ECN/PCN No.: M1733

Product Description: 1200F HIGH CAPACITANCE SUPERCAPACITOR	Abraccon Part Number / Part Series: ADCS-E02R7SA128Q	☐ Documentation only ☒ ECN ☐ EOL	☐ Series ☒ Part Number(s)
Affected Revision: A	New Revision: B	Application:	☐ Safety ☒ Non-Safety

Mechanical Specifications

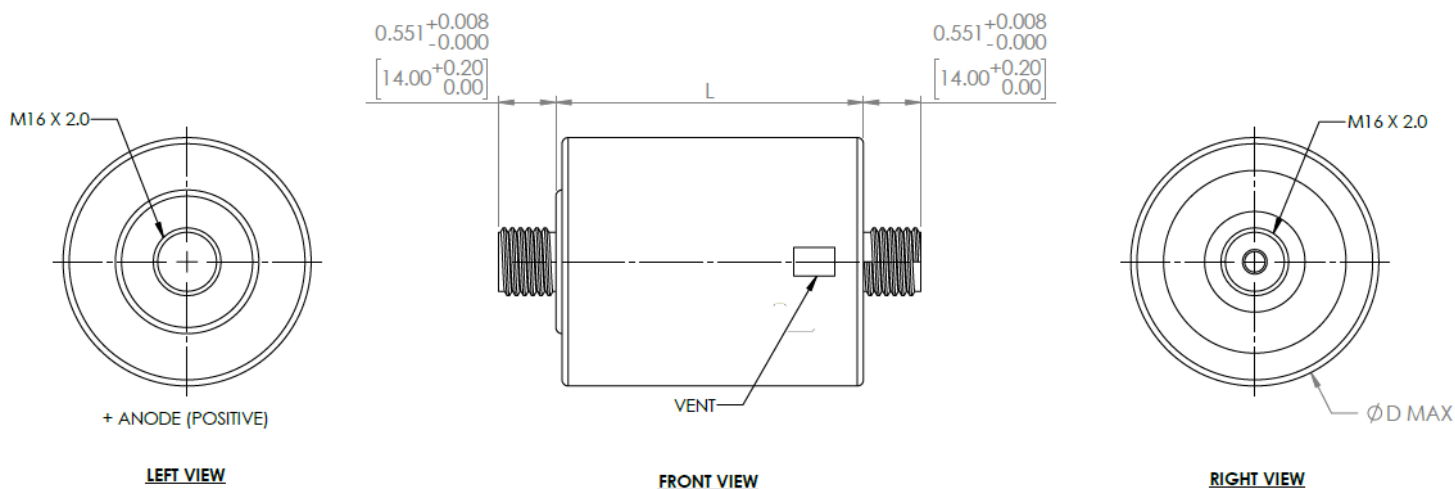
Updating mechanical specs and electrical specs

Small mechanical change may affect product fit. The minor electrical changes should not affect the products performance. Please carefully review.

Dimensions	ØD ±0.5	L ±0.5
ADCS-E02R7SA128	2.387[60.5]	2.913[74]
ADCS-E02R7SA158	2.387[60.5]	3.346[85]
ADCS-E02R7SA208	2.387[60.5]	4.133[105]
ADCS-E02R7SA308	2.387[60.5]	5.433[138]
